SERVICE BULLETIN

2" & 3" Metallic Diaphragm Pumps and Pulsation Dampeners

RELEASED: 12-15-00
REVISED: 1-10-12
REV: 00
BULLETIN: #1-00
FORM: 4471-2

MODELS AFFECTED: 650779-X-B 650784-X-B PX20X-X-X SB20X-X-X
650780-X 650785-X PX30X-X-X-B SB30X-X-X

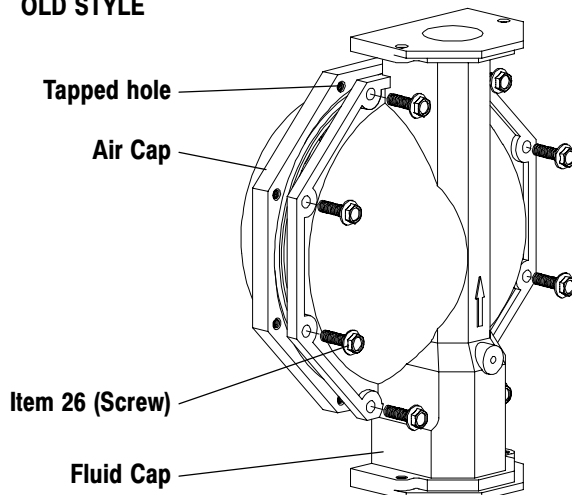
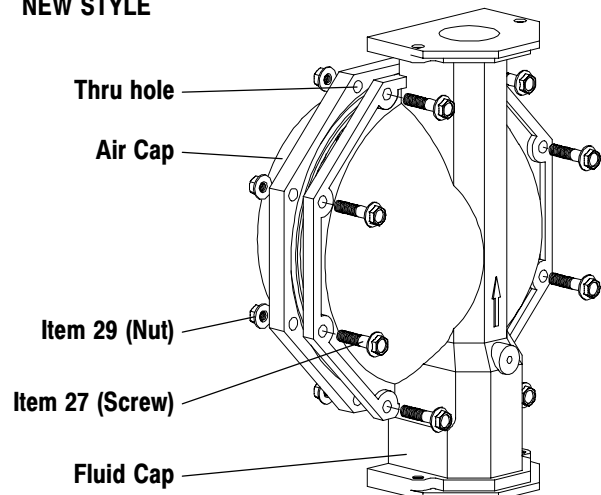
The method for securing the fluid cap has changed from an air cap with (8) threaded holes and screws to an air cap with (8) thru holes, screws and nuts (see figures below).

If field updating is desired, the (8) threaded holes in each air cap can be drilled out to accept the new bolt and nut method. On 2" air caps, drill (8) .437" (11 mm) thru holes. On 3" air caps, drill (8) .531 (13.5 mm) thru holes.
